# Service Information

The M.G. Car Company Ltd.

Date of Issue: March, 1936

## GEARBOX OIL LEAKAGE FROM LAYSHAFT

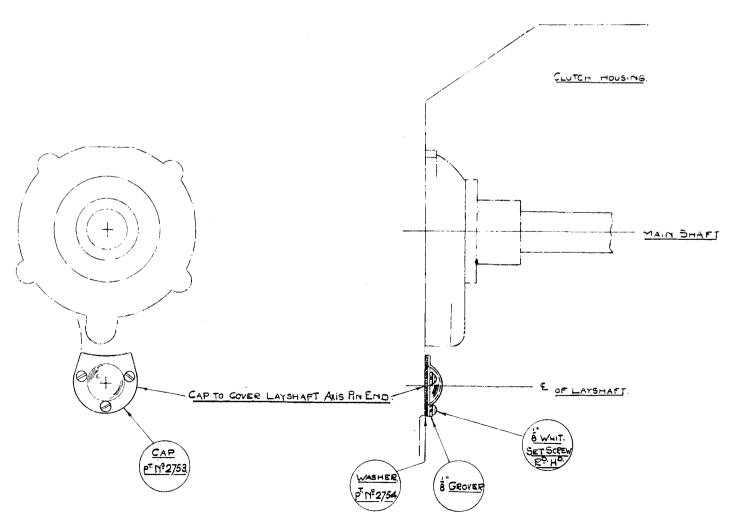
This trouble is not very prevalent, but when it is found a small cover fitted with a washer and three screws can be fitted to prevent a recurrence.

The drawing herewith (Service Blue Print No. 147) gives particulars of the cover, screws and washer, and also shows its location on the gearbox.

#### GEAR LEVER RATTLE

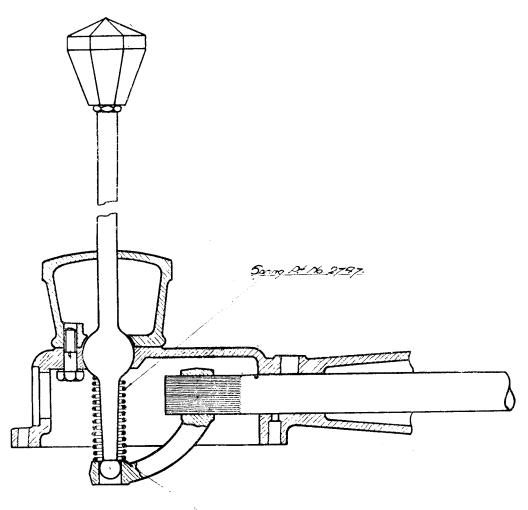
Complaints of rattle in the gear change remote controls have been made from time to time, and up till recently no very satisfactory cure has existed.

It has been found that a spring fitted as shown in the drawing (Service Blue Print No. 146) prevents rattle most effectively.

The Part Number of the spring in question is 2747, and this number, together with the Chassis Number of the car concerned, must be quoted when ordering for service.

## WATER PUMP

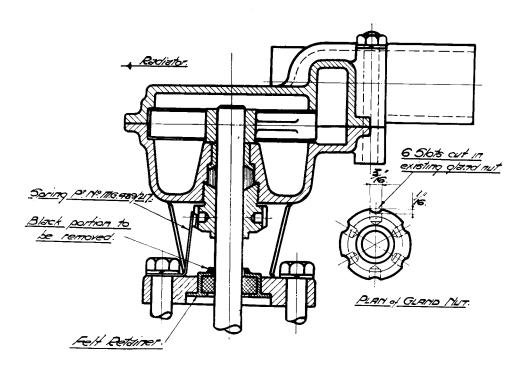
This spring is more positive in action and eliminates the possibility of water (which may leak past the gland) finding its way into the sump past the spindle sealing felt, owing to it being trapped by the coil spring.

This modification is very simple to carry out on all existing pumps.

The existing gland nut is slotted to receive the new spring.

The coil spring spigot is removed from the spindle felt retainer.

#### **CLUTCH MODIFICATIONS**

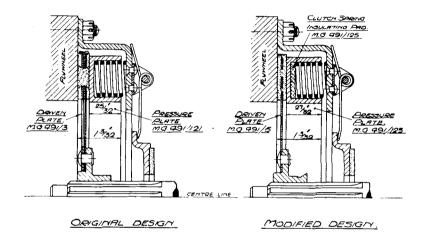
A lighter design of driven plate, with a proportionately thicker pressure plate, has been incorporated in the P. and N. Type clutch.

The sketch given below of the original and modified design of clutch will illustrate this point.

The modified design of clutch consists of a driven plate having a single disc with the lining moulded in position, the pressure plate being  $\frac{27}{32}$  in. thick. Insulating pads are inserted in the spring guide holes to protect the clutch springs from heat.

#### MAGNETO DRIVE

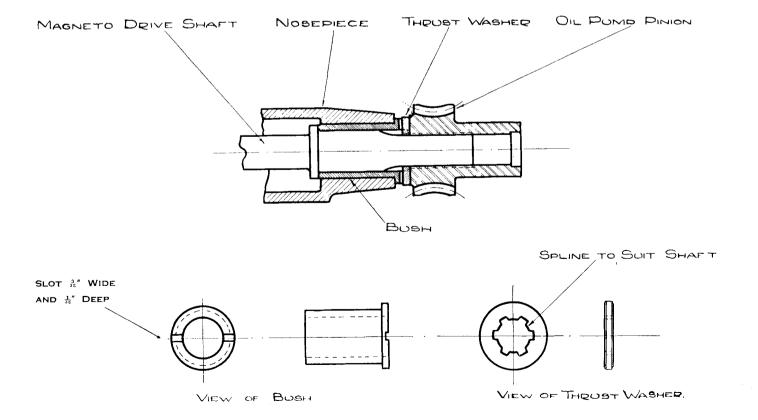
It has been found that the magneto drive thrust washer has been cutting into the splined shaft, causing it ultimately to fail.

Immediate action is necessary to obviate this, and the present washer is to be replaced by a modified one, as shown in the sketch, the washer being splined to the shaft. As the new type of washer has plain faces, oil grooves must be cut in the face of the bush to dimensions as shown in the drawing.

In all probability it will be necessary at the time of modification to change the splined shaft, as wear in the initial stages takes place very rapidly.

The modified washer (Part No. MG.348/298) and splined shaft (Part No. MG.348/227) may be obtained on application being made to the Claims Department.

ORIGINAL ARRANGEMENT OF LOCKHEED PIPES

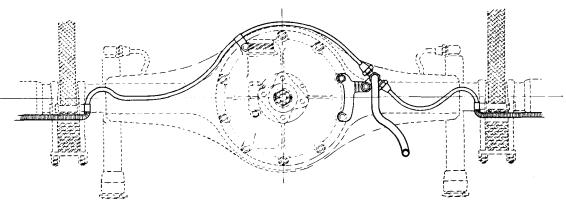
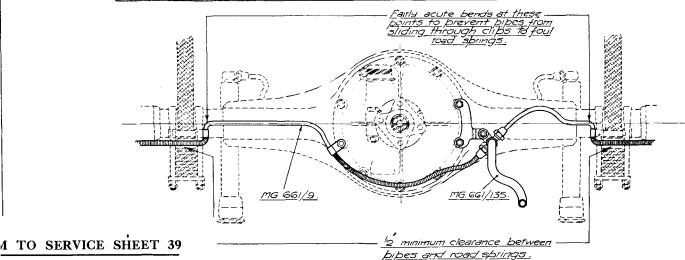
A modification therefore is vitally necessary and consists of reversing the bracket bolted to the rear axle nose piece carrying the "T" piece, also turning the "T" piece into a position when the outlet connections are nearer to the ground.

The sketch illustrates the modification.

#### **BRAKE CABLES**

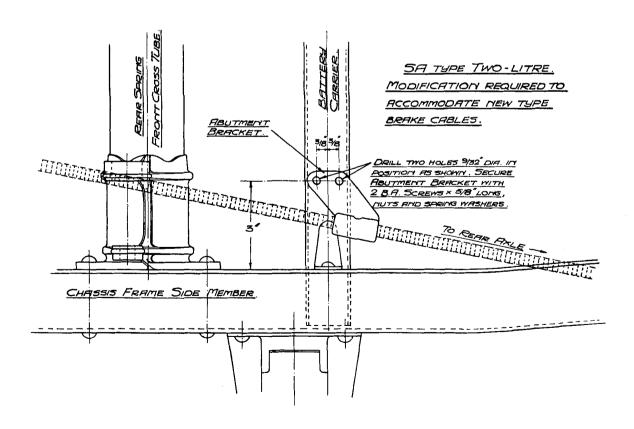
An improved design of brake cable to Part Nos. MG661/26 O/S and MG661/27 N/S, has been introduced on the S.A. Type Two-litre model, commencing at Chassis No. SA1407.

These new cables have been designed to operate through approximately a straight run from the hand brake cross shaft to the rear back plates, when assembled. This feature has necessarily led to the re-positioning of the brake cable abutment brackets.

On cars bearing a Chassis Number previous to SA1407, to accommodate the new cables, it will be necessary to drill two  $\frac{9}{32}$  in. diameter holes in the battery carrier to secure each of the abutment brackets. Particulars of this modification are given in the sketch below. The cables being fitted, it only becomes necessary to connect the Tecalemit pipe line to the abutment bracket when the work is complete.

#### BONNET LOUVRES.

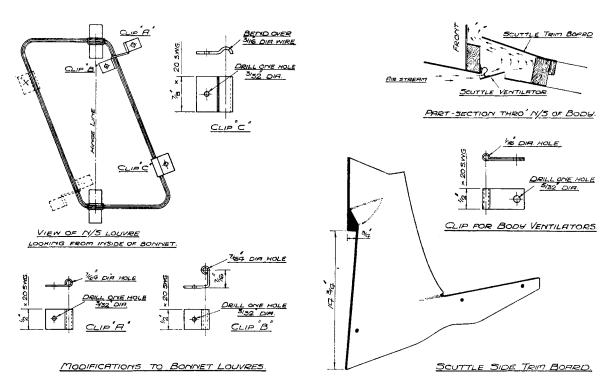
The front two louvres are to open forward instead of backward as previously. Taking each louvre individually, the existing stop clip marked "X" on the illustration need not be removed, but should be bent back toward the bonnet and flattened out. The spring clips can remain, but the spring is removed for further use, as explained below.

The side trim boards will require to be modified in order that in-rushing air is diverted to the front of the scuttle, not only to prevent draught but to give better ventilation. This is illustrated in the view showing a part-section through the near-side of the body.

## CHASSIS DIMENSIONAL DRAWING

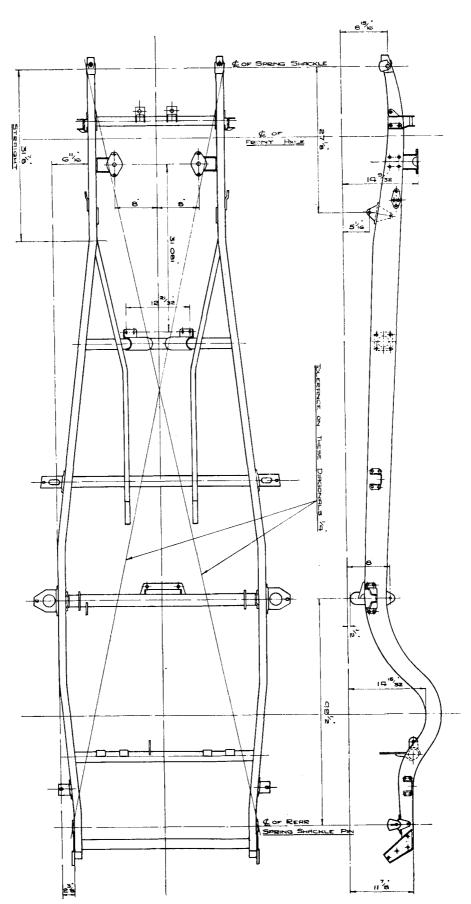
It has been pointed out that the Chassis Dimensional Diagram at present appearing in the Instruction Manual for the 1½-Litre VA. Type is inaccurate. The discrepancies have now been rectified and the correct diagram is given below.

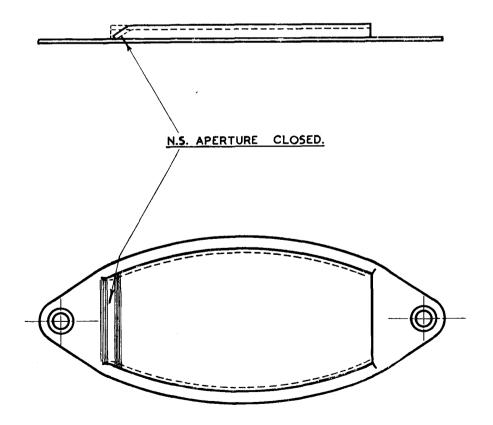
1. A cover must be fitted over the starter pinion. The first few engines were not fitted with them.

The clutch housing must be drilled and tapped to receive the securing screws, the cover can be used as a template for marking the holes.

#### LUBRICATION OF THE KING PINS

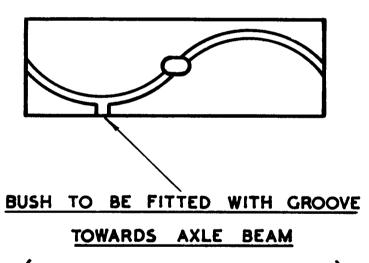
The king pin bushes for the above models have been modified to give more efficient lubrication of the king pins. The oil grooves are designed to lubricate the thrust surfaces also, and it must be noted, therefore, that there is a correct method of fitting the bushes to the stub axle. The same remark applies to both top and bottom bushes.

The sketch below illustrates the modified groove, and it is essential that the bush is fitted so that the oil leak is towards the axle beam.

It should be noted that when the new bushes are pressed into place, it is necessary to use a spiral reamer of sufficient length to do both bushes at the same time.

#### METHOD OF CLAMPING REAR HUB BALL RACE

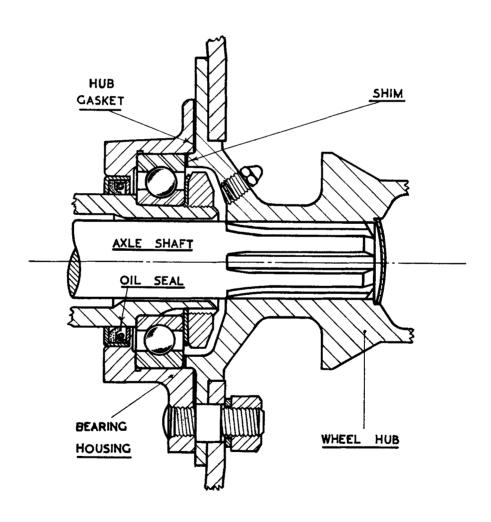
A gasket has been introduced between the rear hub and bearing housing to ensure an oil-tight joint.

In certain circumstances, due to machining limits, the introduction of this gasket gives a clearance between the ball race and the dowel of the hub, which allows the bearing housing to float on the ball race. To overcome this a shim should be fitted as illustrated in the sketch below. SA. Type Two-Litre Shim .010 in. (Part No. MG663/157), and TA. Series Midget and VA. Type 1½-Litre Shim .007 in. (Part No. MG689/143).

- (a) The swivel pin was replaced by one which has its largest diameter shortened to accommodate a thrust washer, and, instead of a threaded portion to secure the ball race, is drilled and tapped to take a bolt to secure a felt washer and cover for dirt exclusion.
- (b) A bronze thrust washer.

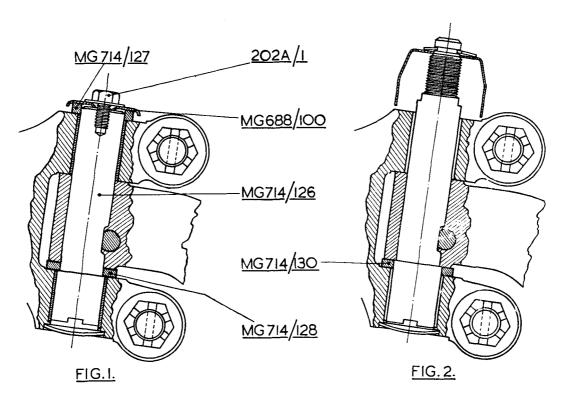
Commencing Chassis No. VA1254 a modification was introduced to the thrust arrangement of the steering swivel pin, the ball thrust race being superseded by a bronze thrust washer.

Reference to Fig. 1 will illustrate this assembly.

To cars having a chassis number prior to VA1254 the above modification can be carried out by fitting the new type swivel pin, thrust washer, felt washer, cover-plate and bolt, all other parts being unaltered.

An alternative method (Fig. 2) enables a slightly modified thrust washer to be fitted to the original swivel pin. This modified washer, Part No. MG714/130, has a larger inside diameter to fit over the largest portion of the original type swivel pin. The ball race must be discarded, but the ball race dust cover and horse-shoe clip is refitted for appearance's sake.

## FAN BELT ADJUSTMENT

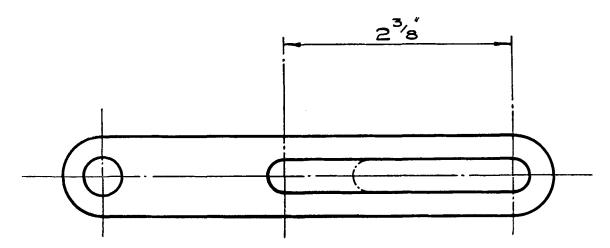
To provide a greater range of adjustment to the dynamo for adjusting the fan belt, a shorter belt is now being fitted. As the new type belt will be supplied for service replacement, it will be necessary to lengthen the slot in the dynamo support, otherwise the belt will be too tight when first fitted. The alteration necessary to the support is illustrated in the sketch below.

#### ALTERATION TO SILENCER FLANGE

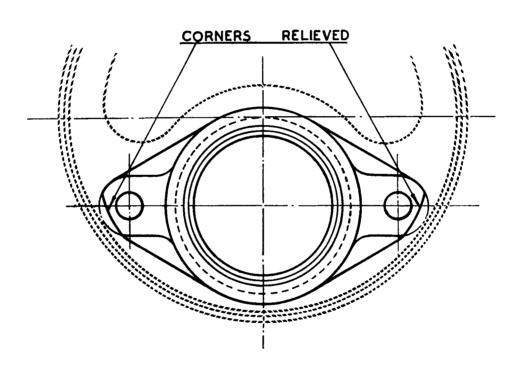
With the introduction of a slightly smaller diameter silencer on the Two-Litre model, it should be noted that, when fitting the new silencer as a replacement on the earlier cars, it will be necessary to relieve the corner of the exhaust pipe flange as illustrated.
